COUNTY OF SAN DIEGO
DEPARTMENT OF HEALTH SERVICES

MEMORANDUM

RE: Legal T M 4977

Site Huntley Rd, Fallbrook

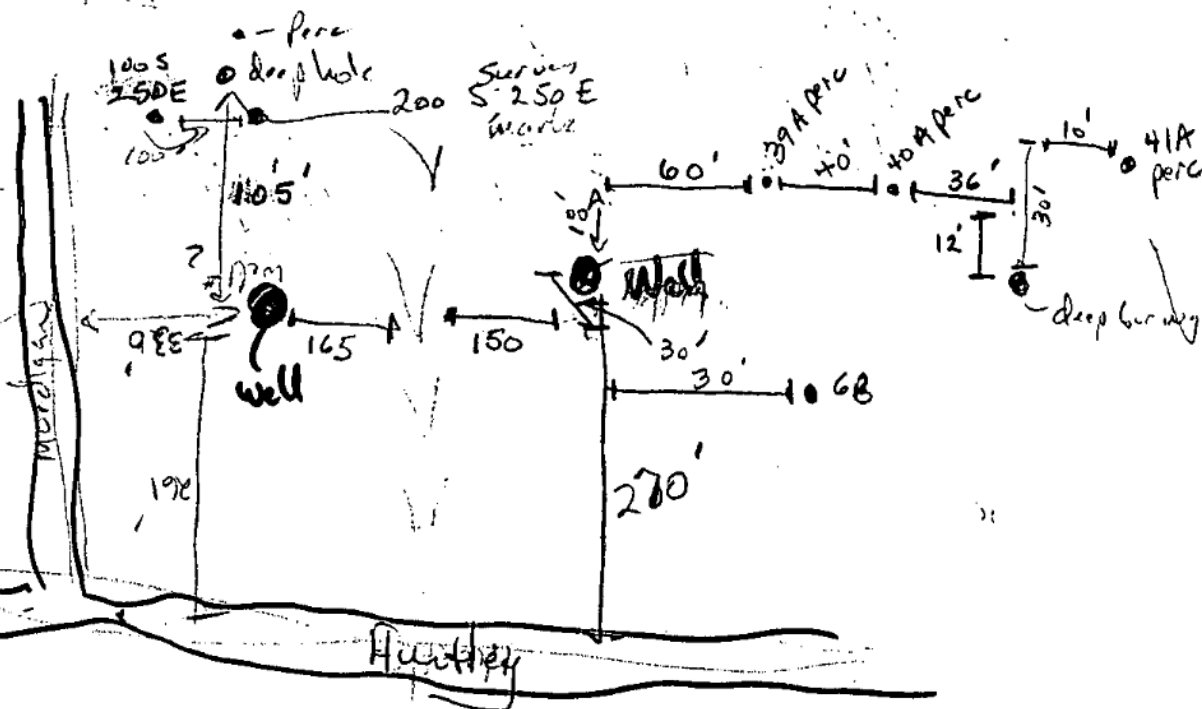
while reviewing site for well permits
recent perc's + test borings were found
within 100' of well sites - (wells were drilled
before permit applied for) - at the ~
Locations - shown -
